**TOWN OF NEWBURGH
PLANNING BOARD
TECHNICAL REVIEW COMMENTS**

PROJECT: MAHER – 50 COCOA LANE
PROJECT NO.: 21-09
PROJECT LOCATION: SECTION 34, BLOCK 2, LOT 71.34
REVIEW DATE: 8 JULY 2021
MEETING DATE: 15 JULY 2021 2021
PROJECT REPRESENTATIVE: ENGINEERING & SURVEYING PROPERTIES

**RE: W.O. # 1325.02
PB APPLICATION 2021-09
MAHER – COCOA LANE
50 COCOA LANE
COMMENT RESPONSE**

ABSORPTION TILE FIELD OVERALL PLAN

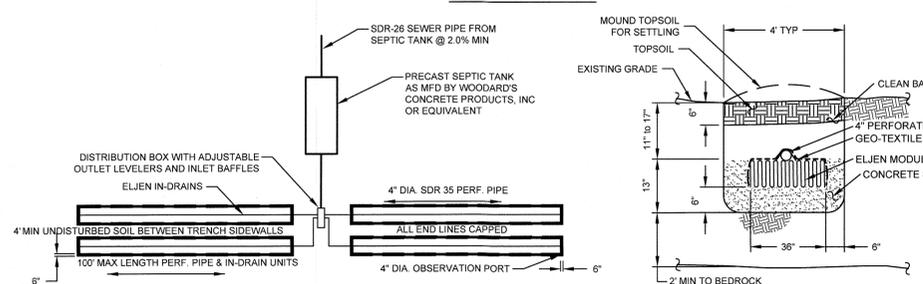
5. Detail "Absorption Tile Field Overall Plan" on Sheet C-2 has a "Typical Eljen Trench Section" which specifies the use of concrete sand.
